CITY OF SAINT LOUIS

ADDENDUM NO. 3

UNION/LINDELL BRIDGE REPLACEMENT

DATE: **10/26/26**

2B.2

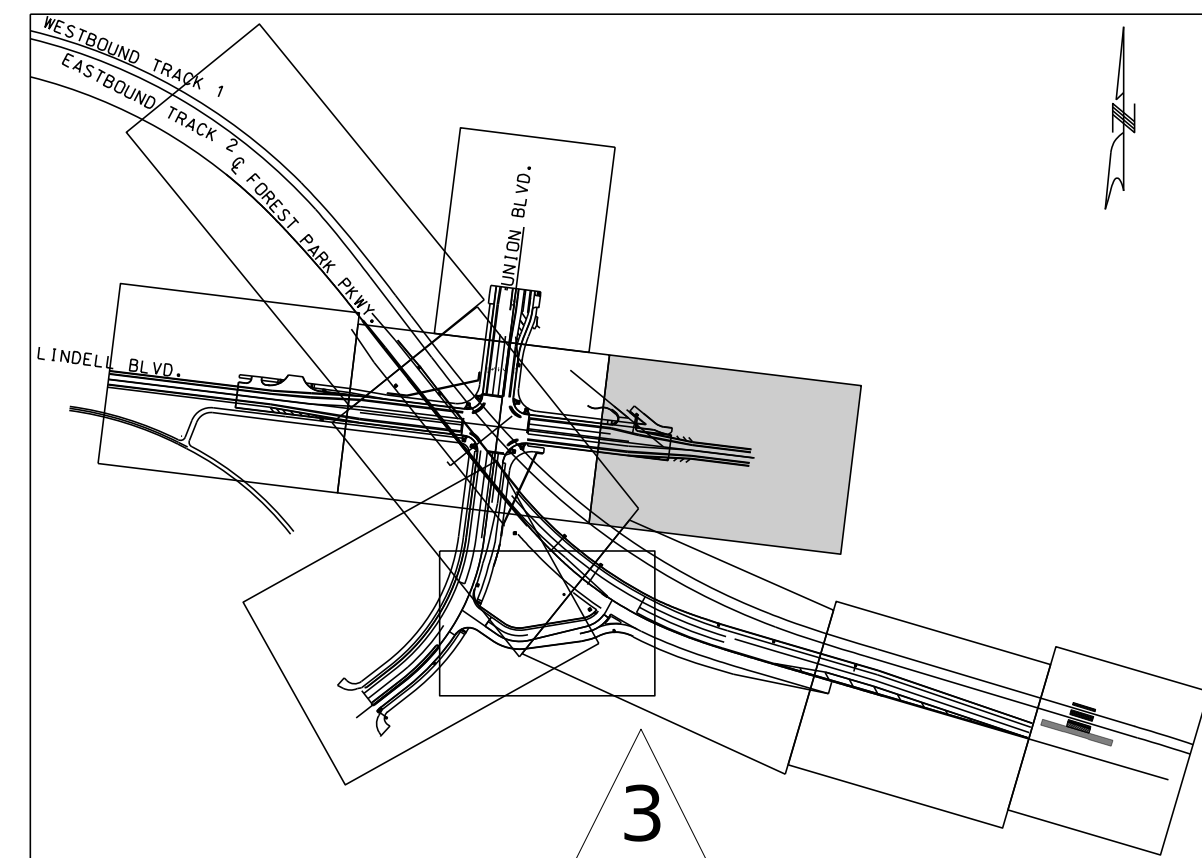
- Revise the quantity of line item "2063000 - Class 3 Excavation" from 1849 CY to 1876 CY.
- Revise the quantity of line item "7259903 - 12" PVC Pipe" from 120 LF to 99 LF.
- Revise the quantity of line item "7319902 - MSD Manhole" from 1 EA to 2 EA.

- The following plan sheets have been revised to reflect updated sewer work:
 - 2B.2, C4.3, C7.1 through C7.9, C7.11, and C7.14
- The following plan sheets have been revised with details regarding the pole foundations for bridge mounted lighting.
 - B-004, B-044
